NOV 19 2019
OCD ArtesiaForm 3160-5
(August 2007)UNITED STATES
DEPARTMENT OF THE INTERIOR
BUREAU OF LAND MANAGEMENT
DISTRICT/ARTESIA/O.C.D.FORM APPROVED
OMB No. 1004-0137
Expires: July 31, 2010**SUNDRY NOTICES AND REPORTS ON WELLS**
Do not use this form for proposals to drill or to re-enter an abandoned well. Use Form 3160-3 (APD) for such proposals.5. Lease Serial No.
NMNM05855

8. Well Name and No.
DITKA FEDERAL COM #19. API Well No.
30-015-3738410. Field and Pool or Exploratory Area
PAVO MESA; ABO11. Country or Parish, State
EDDY, NM

MACK ENERGY CORPORATION
DITKA FEDERAL COM #1

Permanent Abandonment of Federal Wells
Conditions of Approval

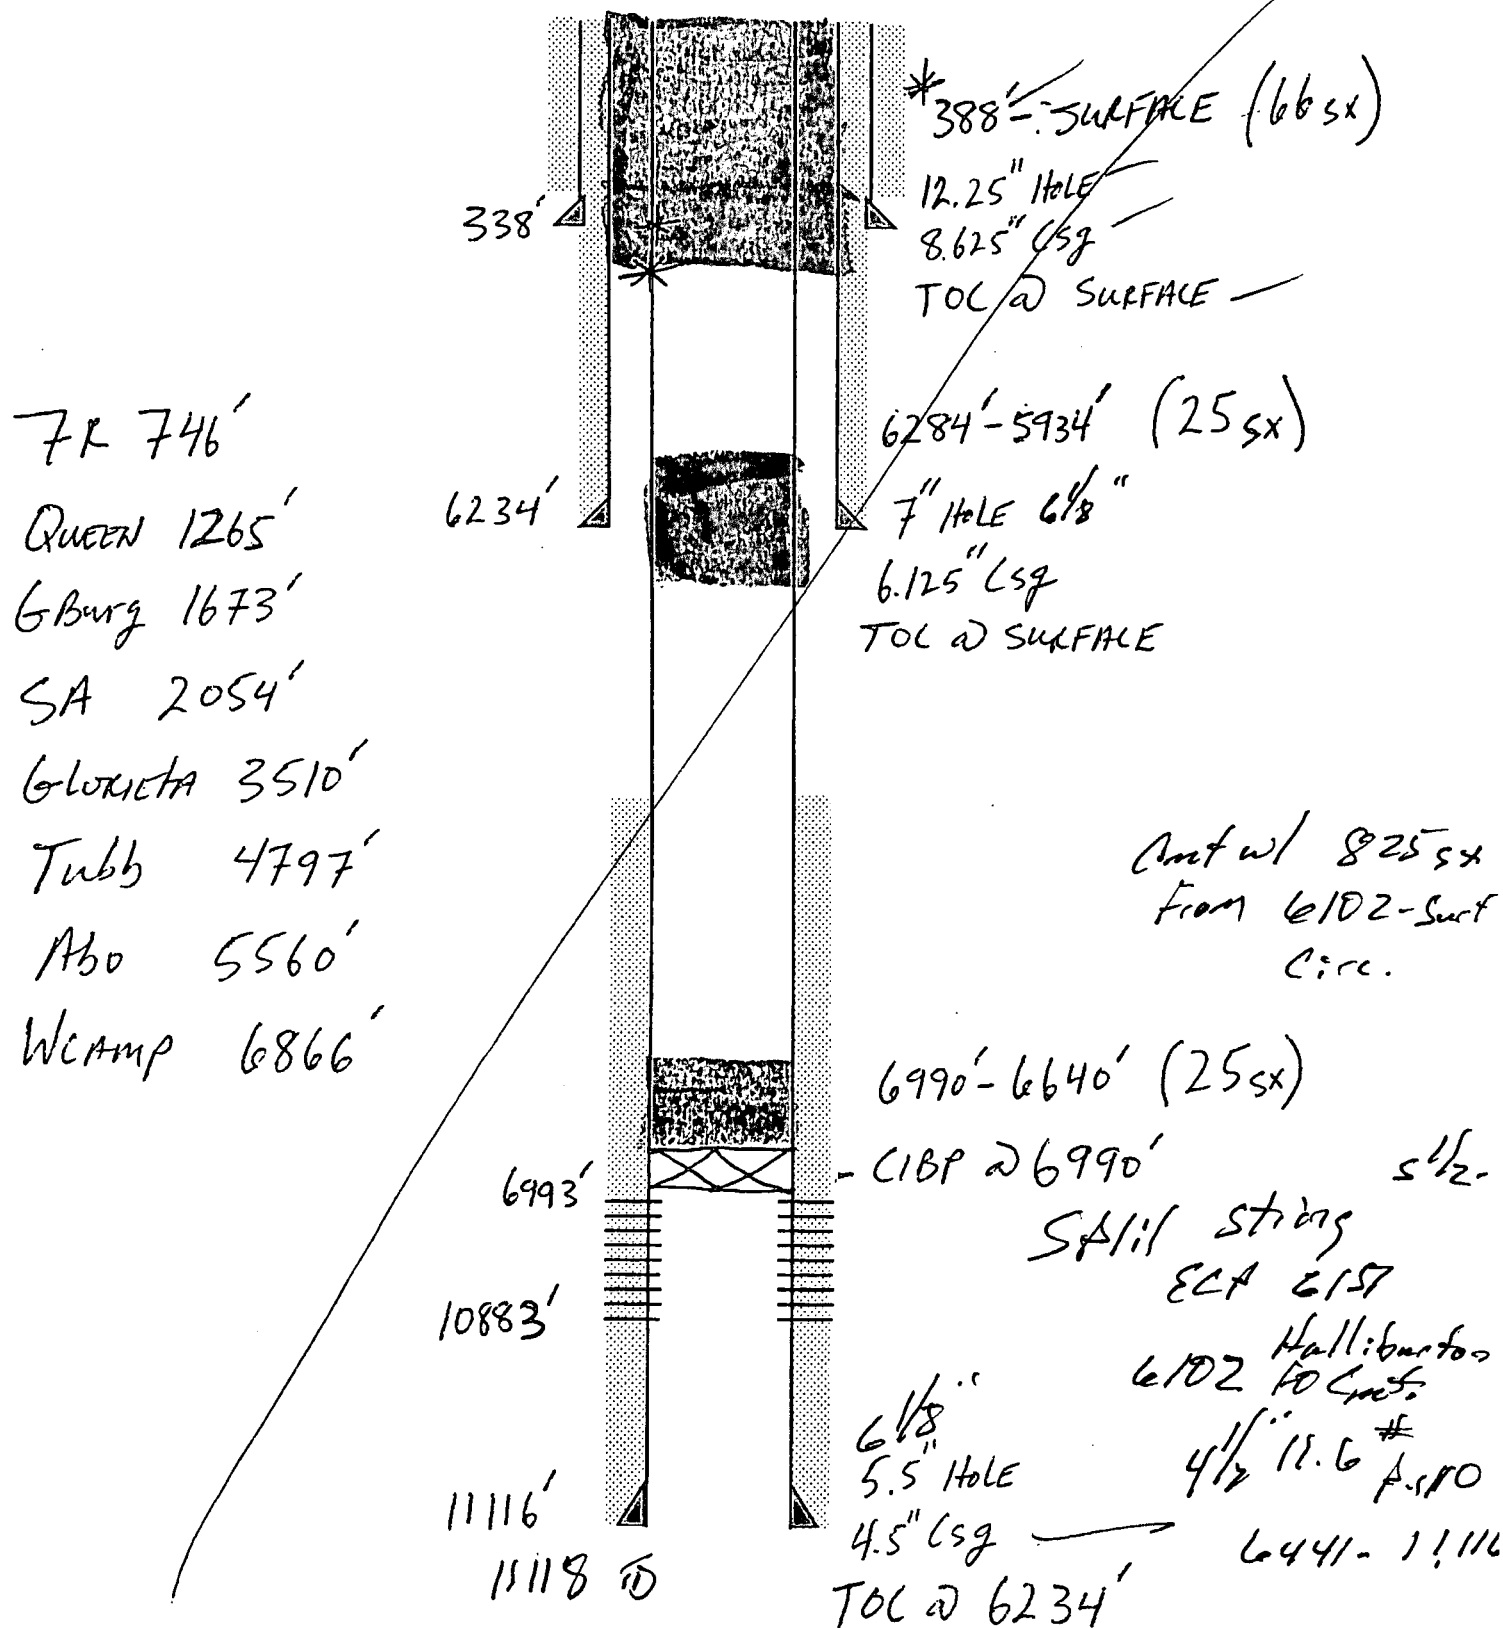
1. SET 4-5" CIBP @ 6990' - PRESSURE TEST CSG, CIRC HOLE W/ MLF 5.5" @ 6100'
 2. SPOT 25 SX CMT @ 6990' - 6640' - WOC & TAG 6100 - 5900
 3. SPOT 25 SX CMT @ 6284' - 5934' - WOC & TAG 5610 - 5410 (T/1460)
 4. PERFORATE @ 388' & SQZ 66 SX CMT FROM 388' - SURFACE 438 SQZ Lnt
 5. CUT OFF WELLHEAD, VERIFY CMT TO SURFACE, WELD ON P&A MARKER
 (BELOW GROUND LEVEL DRY HOLE MARKER REQUIRED) Surf

GC 11/20/19
Accepted for record - NMOCSEE ATTACHED FOR
CONDITIONS OF APPROVALAdd Plug: 3560 - 3360
(T/Glorietta)Add Plug: 2104 - 1904.
(T/Son Andres)Add Plug: 796 - 696
(T/7R)14. I hereby certify that the foregoing is true and correct. Name (Printed/Typed)
KEVIN PERANTON

25 SX 796-696 (T/7R)
6 1/8" hole

25 SX 2104-1904 (T/SA)

25 SX 2560-3360 (T/GL)

Split string
25 SX 5610-5410 5 1/2" (T/ABO) 0-6234
6100-5900 To 9
5 1/2" 25 SX cnt
CIBA 6100
